<p>DECISION OF NORTH SYDNEY LOCAL PLANNING PANEL MEETING HELD ON 5 APRIL 2023</p>

DA No:	418/21
ADDRESS:	37 Bay View Street, Lavender Bay
PROPOSAL:	Erection of Dwelling house and associated works
REPORT BY NAME:	Jim Davies, Executive Planner
APPLICANT:	P Dugal C/- Architecture Saville Isaacs

ADDRESS/WARD: 37 Bay View Street, McMahons Point**APPLICATION No:** 418/21**PROPOSAL:** Erection of dwelling house and associated works**PLANS REF:**

OWNER: P Dugal**APPLICANT:** P Dugal, C/- Architecture Saville Isaacs**AUTHOR:** Jim Davies, Executive Planner**DATE OF REPORT:** 23 March 2023**DATE LODGED:** 3 December 2022**RECOMMENDATION:** Deferred Commencement

Rear, eastern elevation, with silhouettes of extant dwellings north and south of the site.

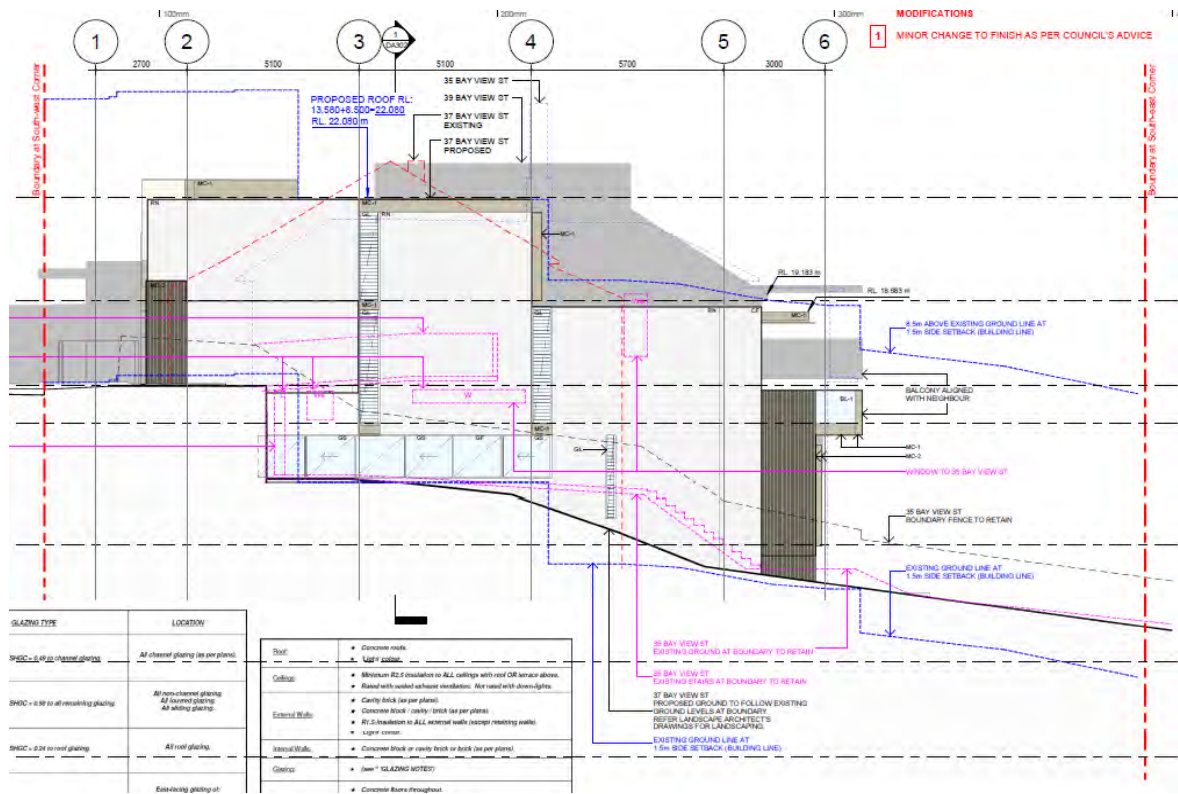
- e) The floor to ceiling height windows and sliding doors to the eastern elevation of the 1st floor bedroom are to be replaced with a solid wall and/or window seat to a maximum height of 800mm, with windows from the top of the window seat to the ceiling. At least one of these windows must be openable to allow access to the roof and garden for maintenance and repairs.

- g) The solid to void ratio in the eastern harbour facing elevation shall be revised to reduce the amount of glazed area and increase the solid portions of the elevation, to comply with clause 1.4.12 Colours and Materials, Provision 4, of Part B, Residential, North Sydney Development Control Plan 2013.

No 39 Bay View

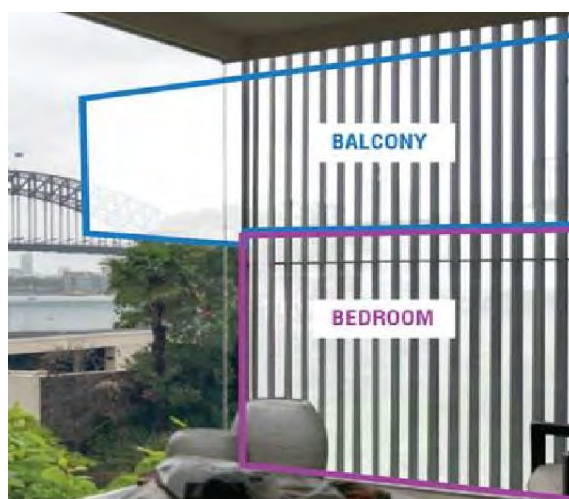
This image was submitted to indicate the proximity to the main bedroom at No 39, of a bedroom and the 'ground floor' balcony as proposed. A slotted window is provided for proposed bedroom 2, which is angled toward the bay, not towards the neighbouring residence (see drawing DA103). The proposed balcony has a partial impact on the view of the bridge, from where the image was taken.

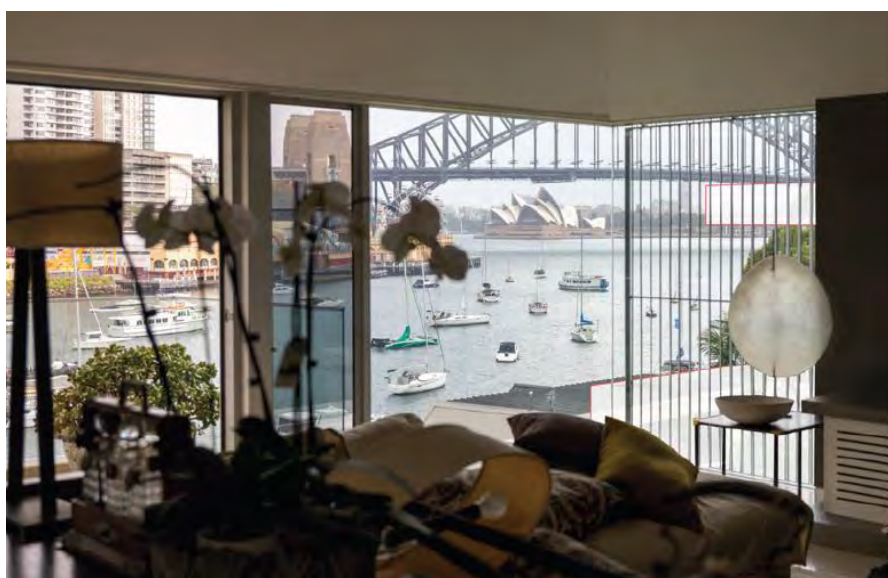
Observing the harbour view from a position to the left of, and/or closer to the window than this viewpoint, would lessen or potentially avoid this impact. Furthermore, the view from the lounge room of this dwelling (shown below), in 'tenacity terms', is arguably more significant or of higher value than the view from a bedroom.

This image is taken from the lounge room of the residence at No 39. To the right can be seen a 3D model of part of the proposed ground floor balcony and the awning above, in white with red edge. From this viewpoint, the balcony has negligible impact on the vista's key elements. Taking 'Tenacity view sharing principles' into account, given the proposal's critical envelope elements are compliant and this view is over a side boundary, the effect is insignificant and there are no grounds to modify the design. Again, changing the viewpoint, would reduce or eliminate the slight impact. And as pointed out by the applicant, the privacy louvres (right hand side of the image) already affect the view, being in front of the part of the proposal visible from this room.

Date	Rev	Issue	CLIENT	PROJECT	TITLE
2021.11.11	A	DA	T + P DUGAL	37 BAY VIEW STREET LAVENDER BAY, NSW	Plan_Ground (Garage)
2022.11.09	C	DA - Additional Information			JOB No. 2033
					DRAWING No. DA104
					REV. C

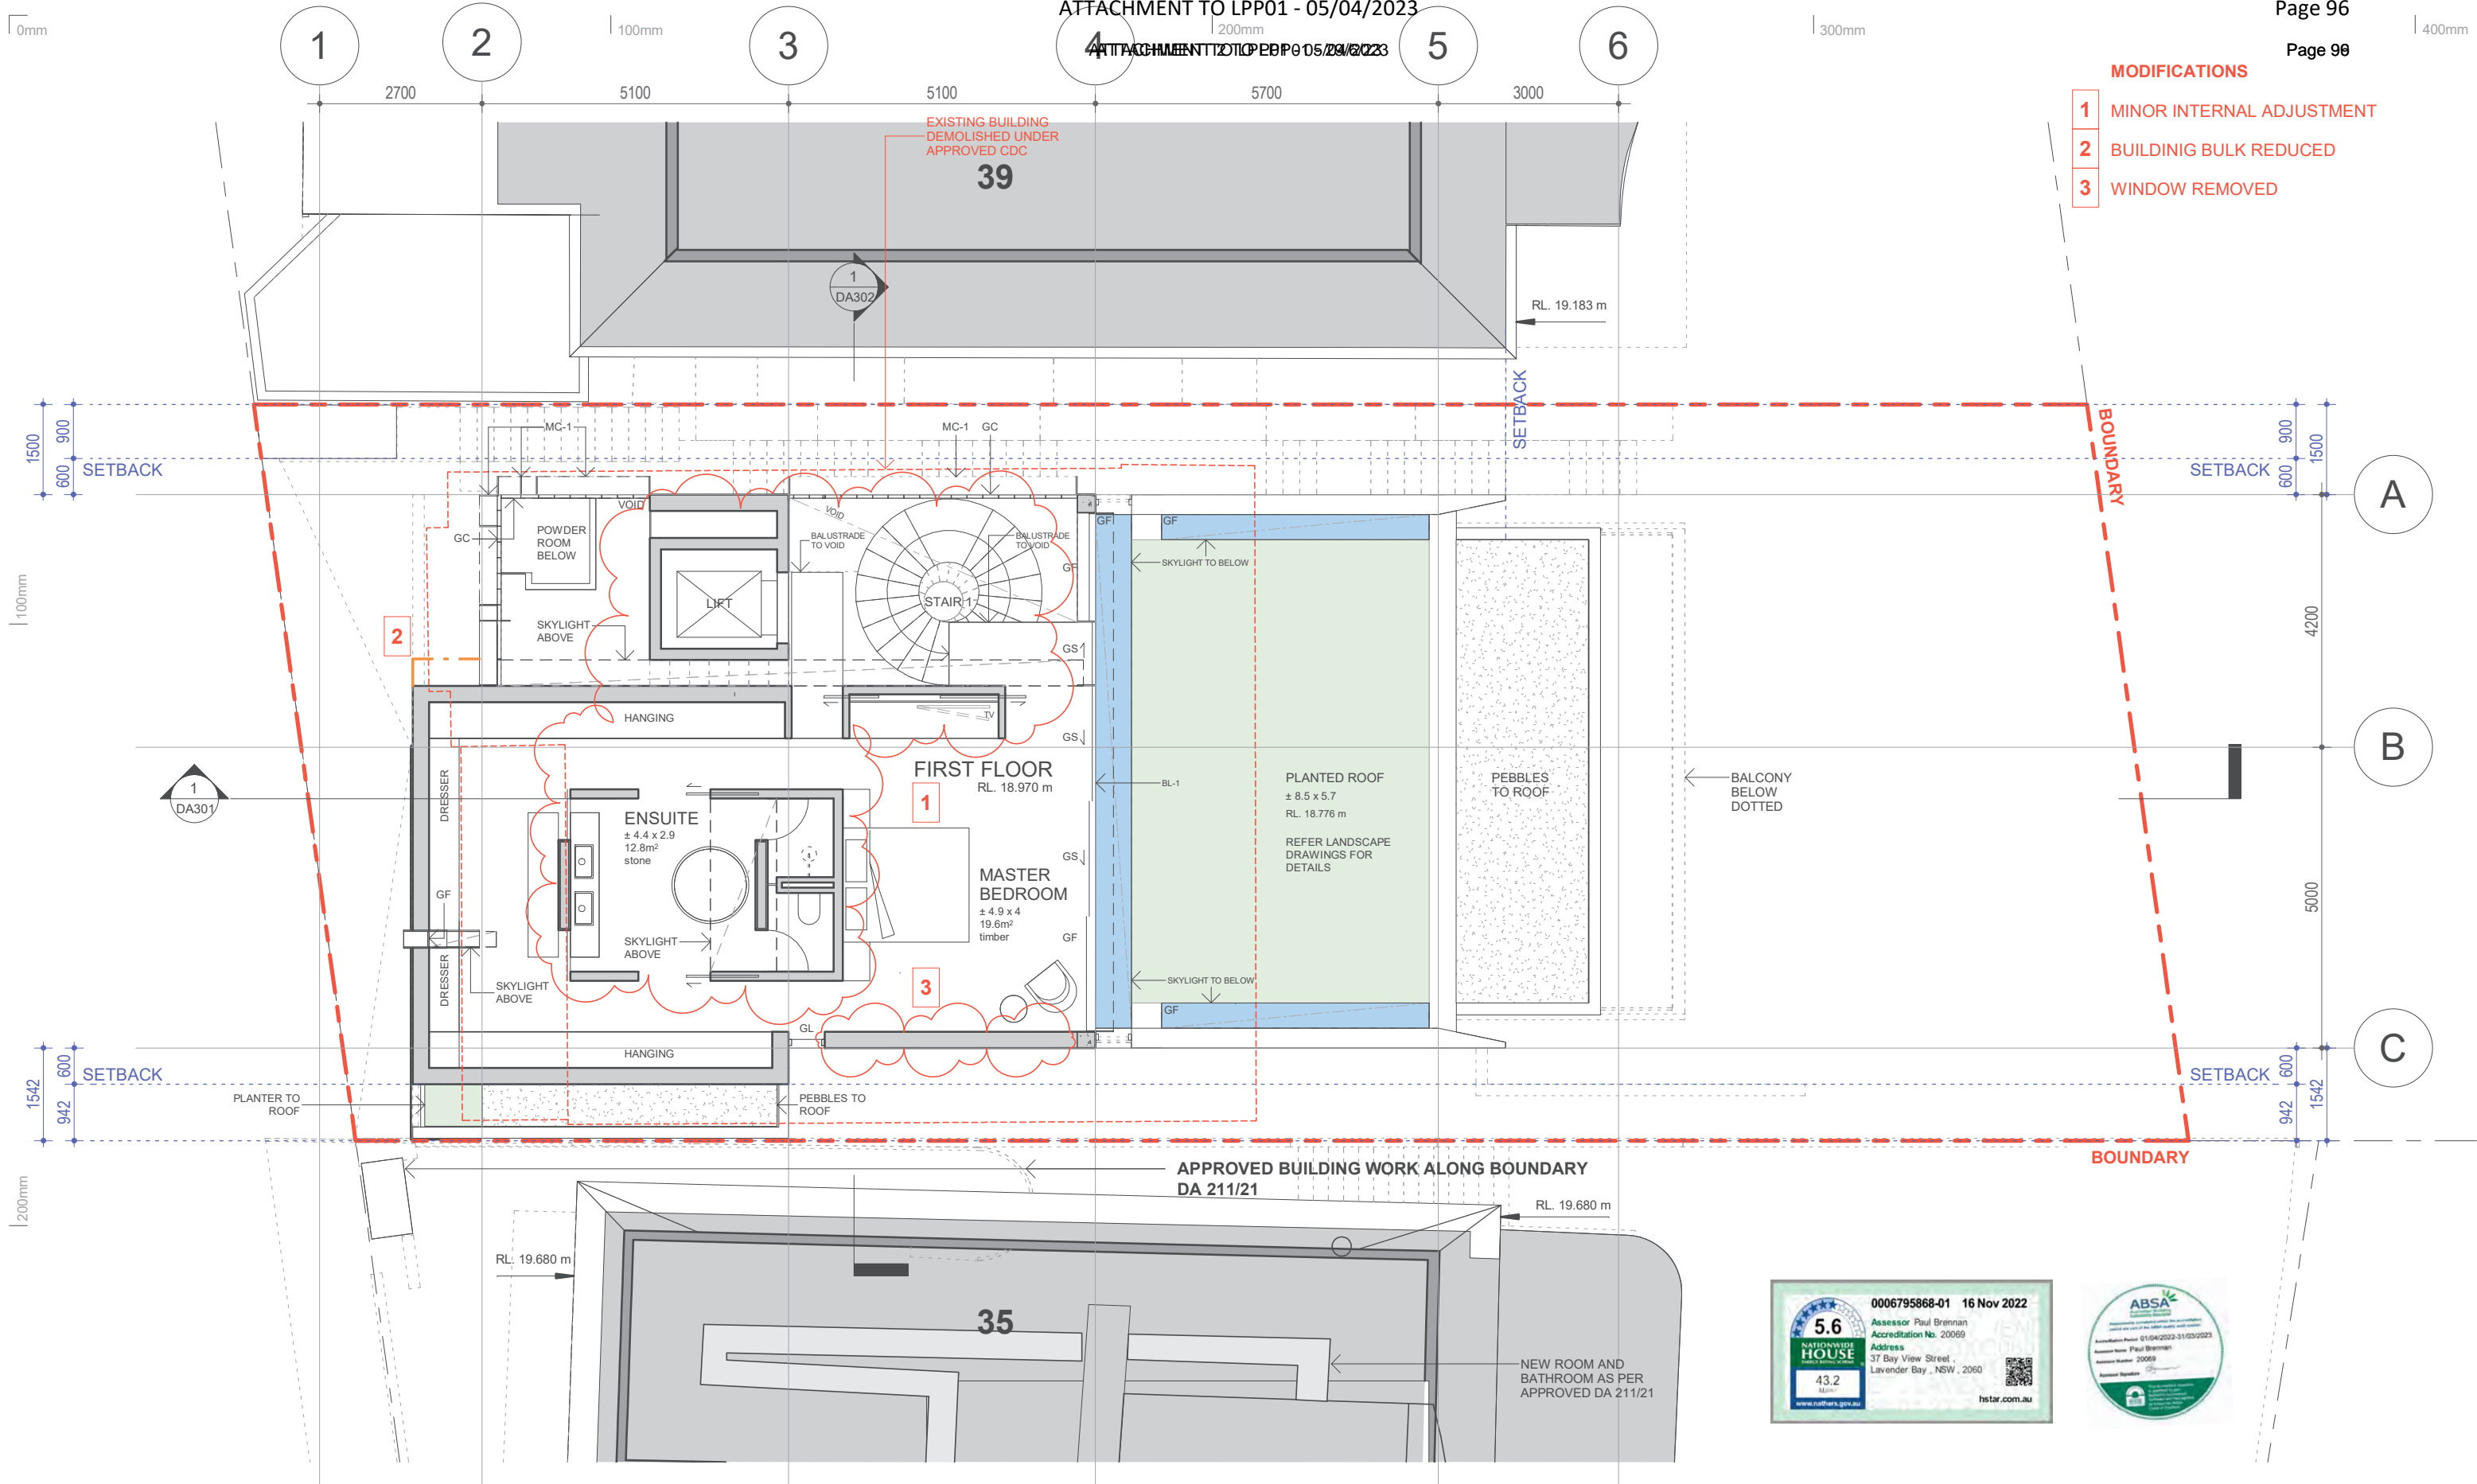
- 1 MINOR INTERNAL ADJUSTMENT
- 2 DRIVEWAY CROSSING SHIFTED SOUTH TO MOVE OUTSIDE OF SRZ

Date	Rev	Issue	CLIENT	PROJECT	TITLE
2021.11.11	A	DA	T + P DUGAL	37 BAY VIEW STREET LAVENDER BAY, NSW	Plan_First Floor
2022.08.17	B	DA - Adjusted Graphics			JOB No.
2022.11.09	C	DA - Additional Information			2033
					DRAWING No.
					DA105
					REV.
					C

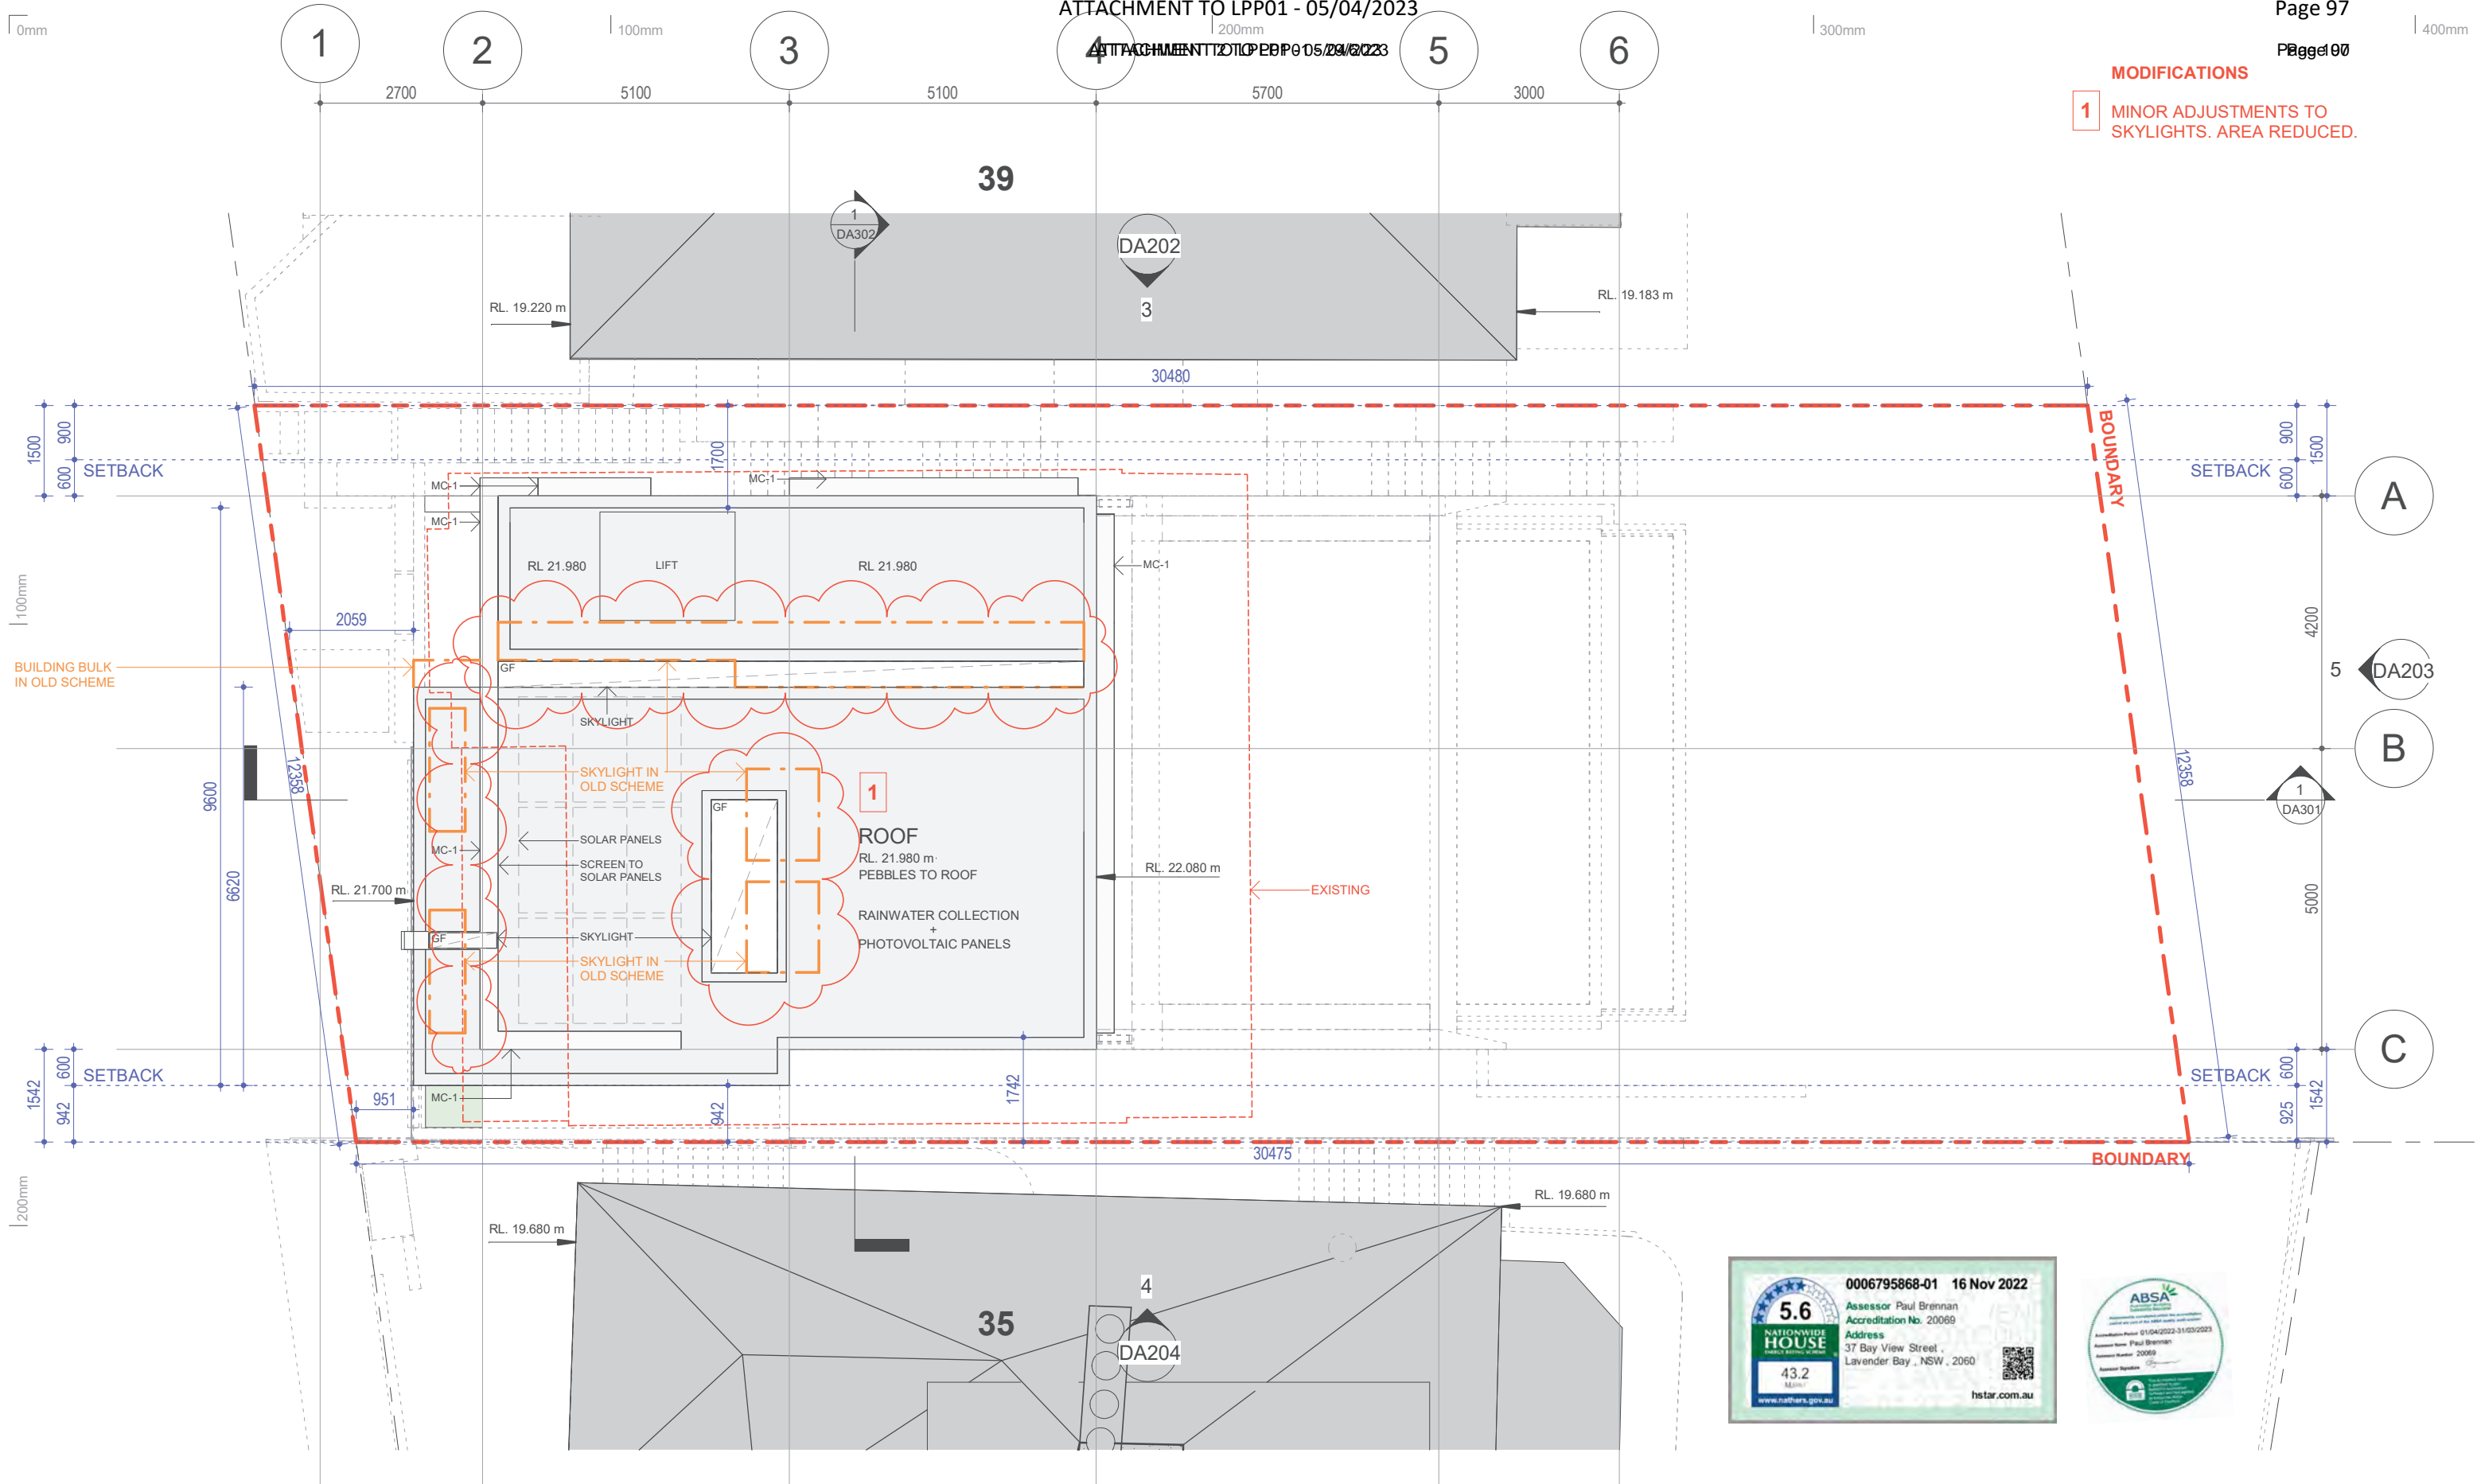
- MODIFICATIONS**
- 1 MINOR INTERNAL ADJUSTMENT
 - 2 BUILDING BULK REDUCED
 - 3 WINDOW REMOVED
